Project	IEEE 802.16 Broadband Wireless Access Working Group <http://ieee802.org/16>	
Title	Complementary document for draft comments	
Date Submitted	2003-11-05	
Source(s)	Yossi Segal Itzik Kitroser Yigal Leiba Zion Hadad Runcom Technologies Ltd. 2 Hachoma St. 75655 Rishon Lezion, Israel	Voice: +972-3-9528440 Fax: +972-3-9528805 yossis@runcom.co.il itzikk@runcom.co.il yigall@runcom.co.il zionh@runcom.co.il
	Avi Freedman Hexagon System Engineering 21c Yegi'a Kapa'im st. P.O. Box 10149 Petach Tikva, 49001 Israel	Voice: +972-3-9224420 Fax: +972-3-9224396 avi@hexagonltd.com
Re:	Contribution elaborating on comments for letter ballot #13	
Abstract	This document includes text referenced in several comments given for ballot 13	
Purpose	To be integrated into P80216-REVd_D1 document	
Notice	This document has been prepared to assist IEEE 802.16. It is offered as a basis for discussion and is not binding on the contributing individual(s) or organization(s). The material in this document is subject to change in form and content after further study. The contributor(s) reserve(s) the right to add, amend or withdraw material contained herein.

Complementary document for ballot 13 comments

The foll

Figure 246a— Channel Coding Process for regular and repetition coding transmission

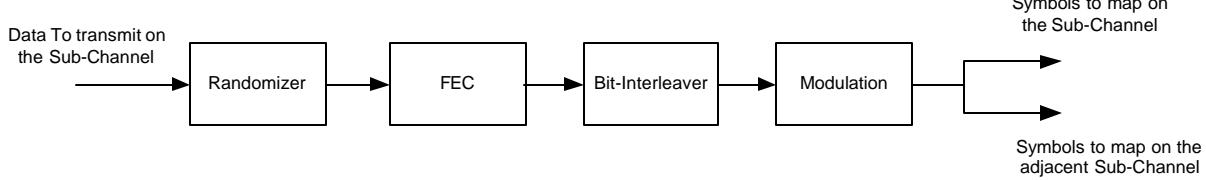
When repetition code is used, allocation for the transmission shall always include an even number of adjacent Sub-Channels. The basic block shall pass the regular coding chain where the first Sub-Channel shall set the randomization seed used in section 8.5.9.1, and the data shall follow the coding chain up to the Mapping. The data outputted from the modulation (section 8.5.9.4) shall be mapped onto the block of sub-channels allocated for the basic block and then it will be also mapped on the following consecutive allocated Sub-Channels (for repetition coding of 2 another block of sub-channels of the same size is used, while for repetition coding of 4 another 3 blocks of sub-channels of the same size are used), the process of regular encoding and repetition encoding is shown in figure 246a
